**INFORMAL REFERRAL COMMENTS – DA 090/M021/20
70 GREENHILL ROAD WAYVILLE**

Construction of a multi-storey, mixed use building comprising residential and commercial uses together with carparking and site works.

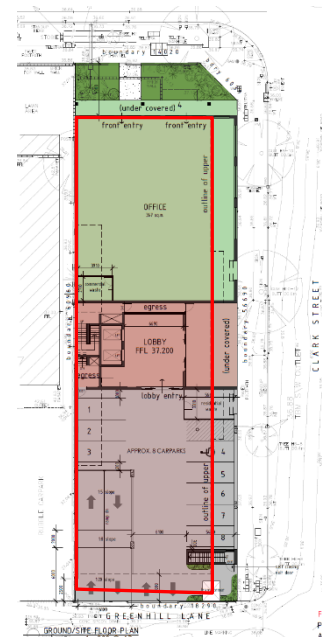
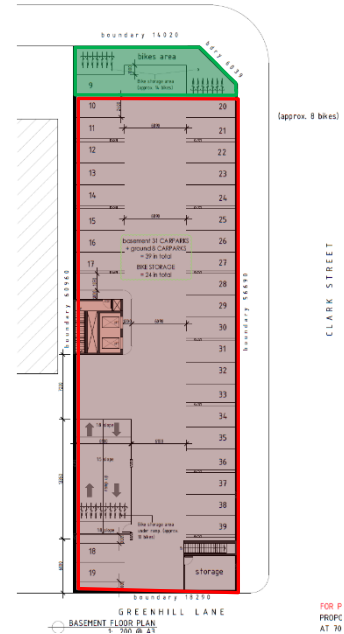
- The Building Interface Envelope (30 degrees at 3m) is applicable from the zone boundary to limit overbearing building mass, overshadowing and provide a proper and orderly demarcation for diverse development. The existence of an atypical non-residential use to the rear does not change the long-term zoning and intended future development nature nor the existence of low-density residential dwellings in proximity to the east and west;
- At the ground level 6.0 metre Greenhill Road setback provided but space encroached in effect by full height solid columns and projecting balconies;
- Rear lane setback of 6.5 metres from opposite side, and therefore 0.4 metres from boundary, provided for;

- At the ground level Clark Street 0.0m setback does not address required 3.0m side street setback, providing no relief to street from long, harsh and plain building façade and excessive building foot print of 86% compared to conforming one of 75%. Acknowledge setback provided above ground level, for residential amenity and building articulation;

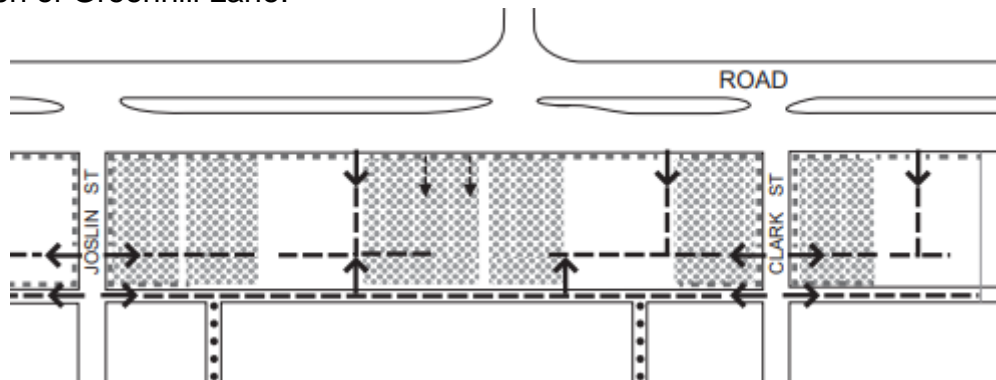
Vehicle access is entirely from Greenhill Lane (6.1 metres wide) and via two two-way crossovers (comprising 12.2 of 18.1 metres frontage). This replaces the existing single two-way crossover to Greenhill Lane.

The two-way access to Greenhill Lane is indicated to be 6.1 metres (inclusive of 0.3 metre clearances which is minimal) and would likely leading to potential conflict between entry and exit movements, traffic queuing and interrupting on-street movement. The accessways should be clearly divided and line-marked to avoid this.

- The two two-way rear accessways be clearly divided or line-marked to avoid vehicles not staying in their path and blocking opposite movement and interrupting on-street movement;
